UNITED STATES PATENT AND TRADEMARK OFFICE

APPLICATION NO.	FILING DATE	FIRST NAMED INVENTOR	ATTORNEY DOCKET NO.	CONFIRMATION NO.
09/720,762	12/28/2000	Kazuyuki Yanase	114474-14-FESI00002US	5214
38492	7590	10/02/2006	EXAMINER	
WILLKIE FARR & GALLAGHER LLP INTELLECTUAL PROPERTY LEGAL ASSISTANTS 787 SEVENTH AVE NEW YORK, NY 10019-6099			GILLAN, RYAN P	
			ART UNIT	PAPER NUMBER
			3746

Office Action Summary

DETAILED ACTION

Examiner's marked Figure
Please Include in Office Action

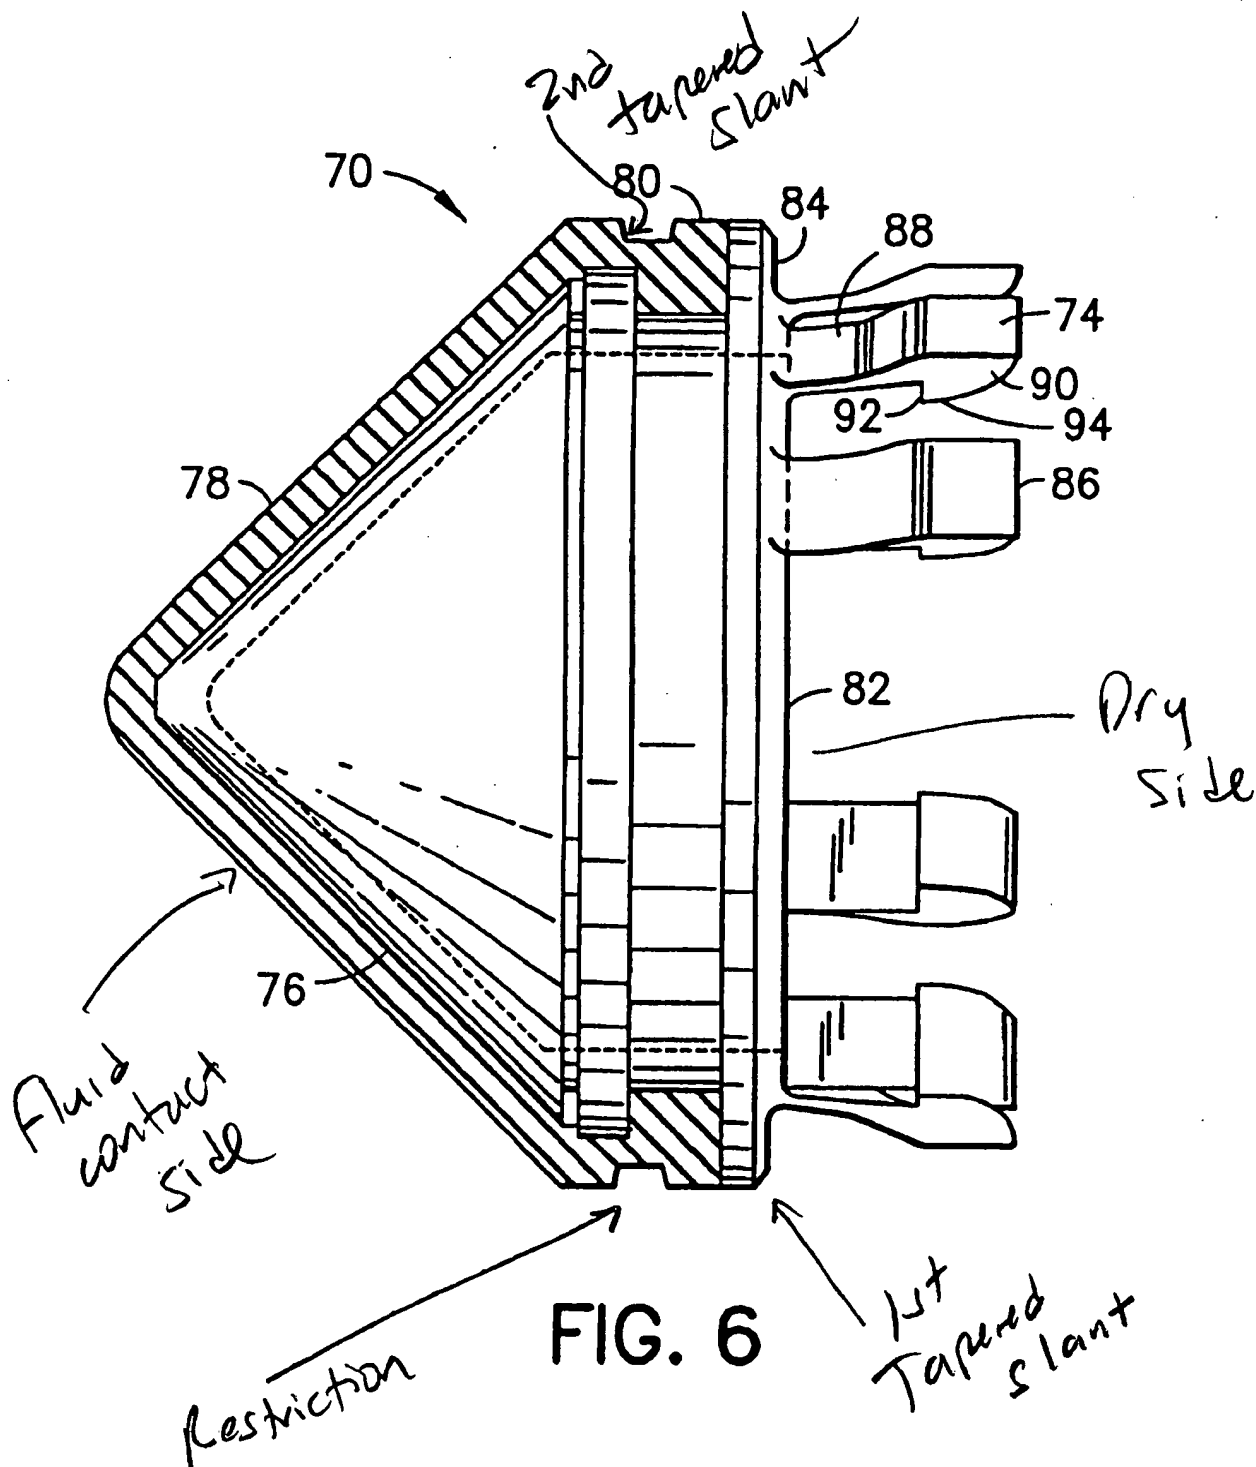
With respect to claims 1, and 3, Trull et al., in Figure 6, disclose a syringe gasket (70) wherein a peripheral side surface (80) of the gasket is in contact with an inner surface of the syringe barrel (60). A restriction (labeled by the examiner on Figure 6 attached to the end of this office action) is provided, and a periphery of a bottom surface

of the gasket that is not in contact with the liquid is formed into a tapered slant (also labeled by the examiner on Figure 6).

With respect to claim 3, the Trull et al. apparatus comprises a tapered slant with a first and second plunger diameter. The examiner has labeled these embodiments on the marked up Figure 6.

With respect to claims 9 and 10, a second tapered (see examiner's marked up Figure 6) slant is formed between the peripheral side surface of the gasket (70) that is in contact with an inner surface of the syringe barrel (60) and the restriction (see examiner's marked up Figure 6). The gasket tightly closing the liquid is an obvious requirement for the syringe to pump fluid properly. A recitation with respect to the material intended to be worked upon by a claimed apparatus, in this case a contrast medium, does not impose any structural limitations upon the claimed apparatus, which differentiates it from the prior art apparatus satisfying the structural limitations of the claims, as is the case here.

With respect to claim 34, the Trull et al. apparatus comprises a tapered slant with a first and second plunger diameter. The examiner has labeled these embodiments on the marked up Figure 6.

With respect to claim 40, a second tapered (see examiner's marked up Figure 6) slant is formed between the peripheral side surface of the gasket (70) that is in contact with an inner surface of the syringe barrel (60) and the restriction (see examiner's marked up Figure 6). The gasket tightly closing the liquid is an obvious requirement for the syringe to pump fluid properly. A recitation with respect to the material intended to be worked upon by a claimed apparatus, in this case a contrast medium, does not impose any structural limitations upon the claimed apparatus, which differentiates it from the prior art apparatus satisfying the structural limitations of the claims, as is the case here.
